DEVELOPMENT APPLICATION ASSESSMENT REPORT

Application Number:	DA2020/1606
----------------------------	-------------

Responsible Officer:	Sarah McNeilly (external consultant)
Land to be developed (Address):	10 Courtley Road, Beacon Hill
Proposed Development:	Construction of a dwelling house
Zoning:	R2 Low density Residential
Development Permissible:	Yes
Existing Use Rights:	No
Consent Authority:	Northern Beaches Council
Land and Environment Court Action:	No
Owner:	Mrs S and Mr F Nile
Applicant:	Jonathan Malota (Allura Homes)

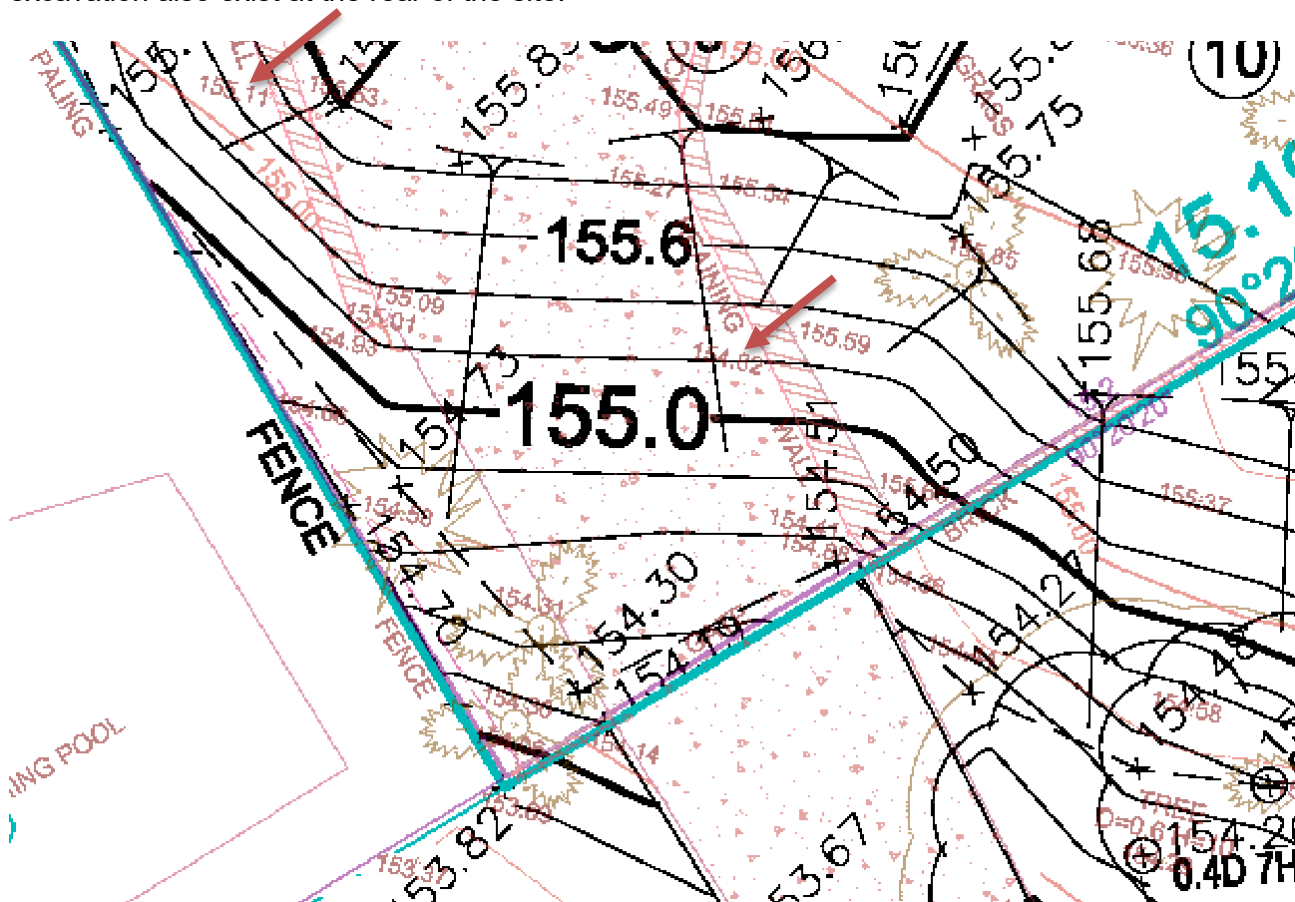
See overlay of the 2018 (shown in red) and 2020 (shown in black) surveys below detailing areas of fill in north eastern corner of site. The greatest areas of fill are on the western side of the original driveway at 1.18m and at the top of the original driveway at approximately 600mm. Large areas of excavation also exist at the rear of the site.
